## **Future Technology Devices International Ltd.**

### **TN\_145 FT311D Errata Technical Note**

**Document Reference No.: FT\_000756**

**Version 1.2**

### 3.2.1 FT311D Enumeration Problem in UART Mode

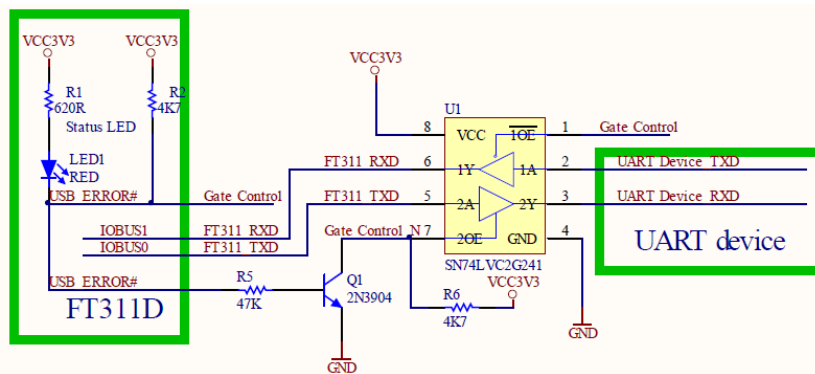
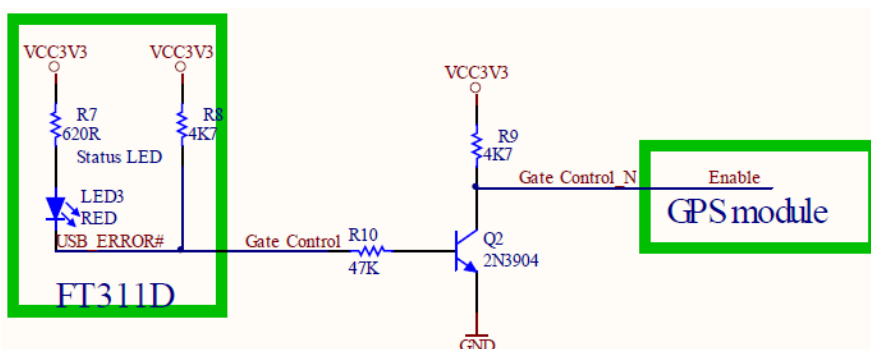
When the FT311D is configured for UART mode and the UART device sends data to the FT311D continuously (such as a GPS module) before the completion of enumeration the device may fail to complete enumeration correctly..

This issue can be averted by disconnecting the TXD signal of UART device from the FT311D RXD signal pin until after the FT311D has established the USB link with Android device.

1. Connected FT311D to Android and complete enumeration.
2. Connect the TXD of UART device to FT311D's RXD then start to receive data.

1. When FT311D connects to the Android device and enumeration is completed, the USB\_ERROR# will become Logic 0 (default Logic 1). This signal can be used to control the TTL gate (74LVC2G241, 74LVC1G125 or others) ON/OFF such that the TXD/RXD lines are connected/disconnected.

2. If the UART device has an enable pins such as on the GPS module, the USB\_ERROR# can also be used. The USB\_ERROR# pin may be inverted with an NPN BJT then connected to the enable pin of the GPS module.

### 3.2.2 FT311D Enumeration Problem in SPI Slave Mode

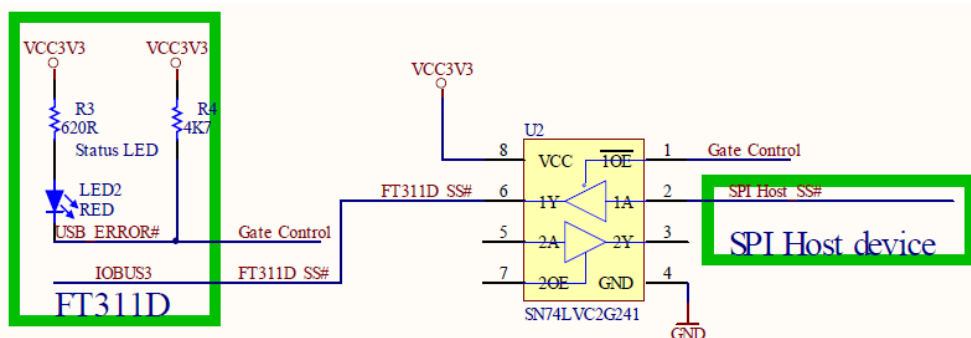
When the FT311D is configured for SPI slave mode and the SPI host device sends data to the FT311D continuously before the completion of enumeration the device may fail to complete enumeration correctly.

This issue can be worked around by disconnecting the SS# signal of SPI Host device until after the FT311D has established the USB link with Android device.

1. Connected FT311D to Android and complete enumeration.
2. Connect the SS# of SPI host to FT311D's SS# then start to communication.

1. When FT311D connects to the Android device and enumeration is completed, the USB\_ERROR# will become Logic 0 (default Logic 1). This signal can be used to control the TTL gate (74LVC2G241, 74LVC1G125 or others) ON/OFF such that the Both SS# lines are connected/disconnected.
